Delegated Report

Application No: 20260267

Location: The Lion PH, Luddesdown Road, Luddesdown, Gravesend

Description: Application for a non-material amendment to the original planning permission reference number 20250053 to allow re-designed/reconfigured concrete ramped access to the Cellar Door Shop and realignment of the existing gabion wall, installation of a new brick / flint wall to meet the realigned gabion wall and the installation of oak arched access gate to the pub garden from the car park; installation of a secondary low level picket style gate and fence to the pub garden; installation of new planter next to new main access gates; installation of new planter adjacent to stepped access to the pub garden; and installation of a set of semi-circle steps up to the Cellar Door shop together with changes approved under reference 20251301 (Application for a non-material amendment to planning permission reference number 20250053 to allow addition of an oak framed entrance porch; amendments to window and door openings; modification to the dimensions of the western toilet block extension; removal of existing external cupboard; minor roof alterations, including changing the restau

Drawing no. 25.36.PL52:

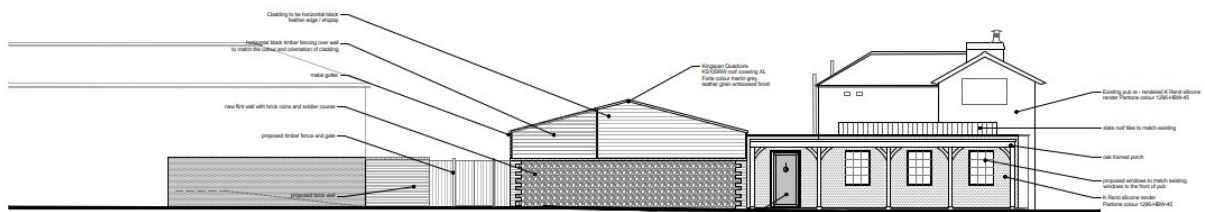
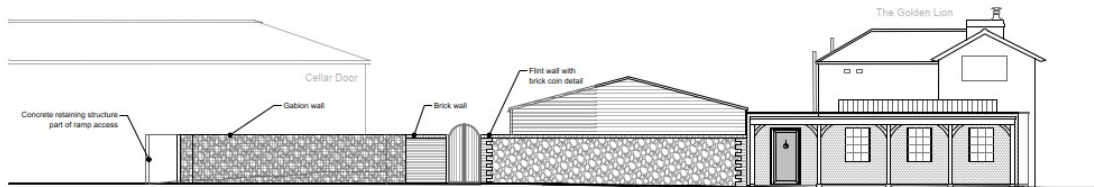
The additional changes subject to this application are a re-designed/reconfigured concrete ramped access to the Cellar Door Shop and realignment of the existing gabion wall, installation of a new brick / flint wall to meet the realigned gabion wall and the installation of oak arched access gate to the pub garden from the car park; installation of a secondary low level picket style gate and fence to the pub garden; installation of new planter next to new main access gates; installation of new planter adjacent to stepped access to the pub garden; and installation of a set of semi-circle steps up to the Cellar Door shop.

The proposed changes to the walls are not significant when compared to what has been granted permission. The access remains the same, just slightly altered. Condition 6 of 20250053 requires full details of boundary treatment to be submitted prior to the bringing into use of the development. This condition is yet to be discharged but should be submitted in accordance with the details set out in this NMA application for consistency.

The oak arched access gate to the pub garden will complement the oak frame that was proposed and approved under reference 20251301 and therefore no objection is raised to this. As above, this should be included in the application to discharge condition 6 of 20250053.

The semi-circle steps are located within the site and therefore will not be readily visible from outside the site. The permitted layout showed just a ramp but this layout shows the semi-circle steps and a ramp. This proposed alteration is not considered a material change to the approved plans and no objection is raised to this.

The proposed changes are considered non-material and therefore the application can be supported.

20250920:

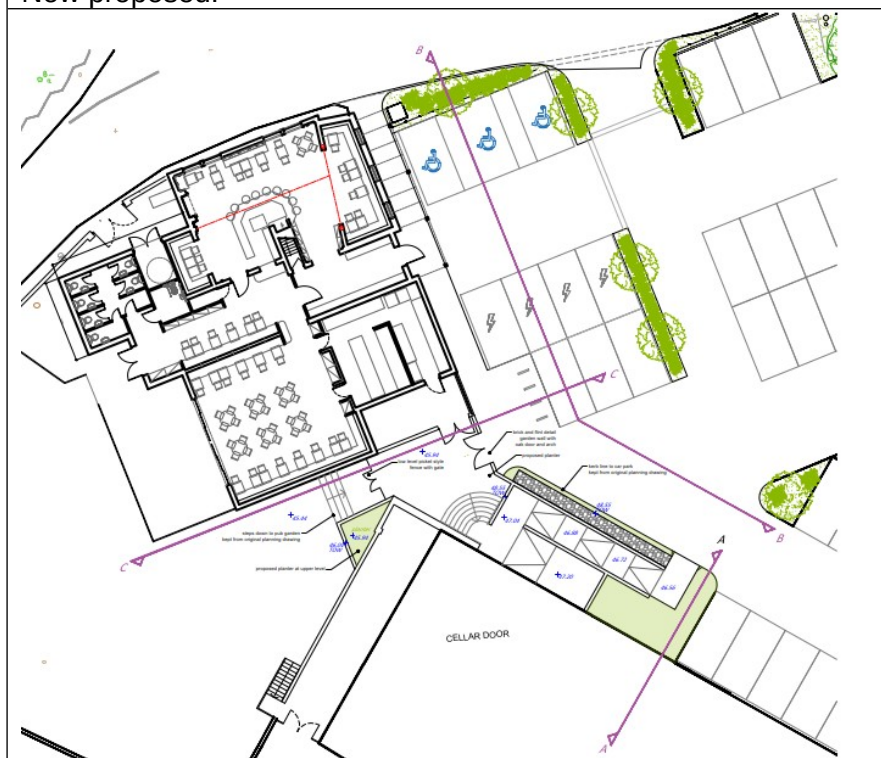
The block plan approved under reference 20250920 is shown below and is partially replaced although the parking spaces and phone box remain as approved:

The changes to the carpark including the loss of two spaces, and the introduction of a red phone box for use as a community library have already been approved under reference 20250920 and have been included on the plans for completeness.
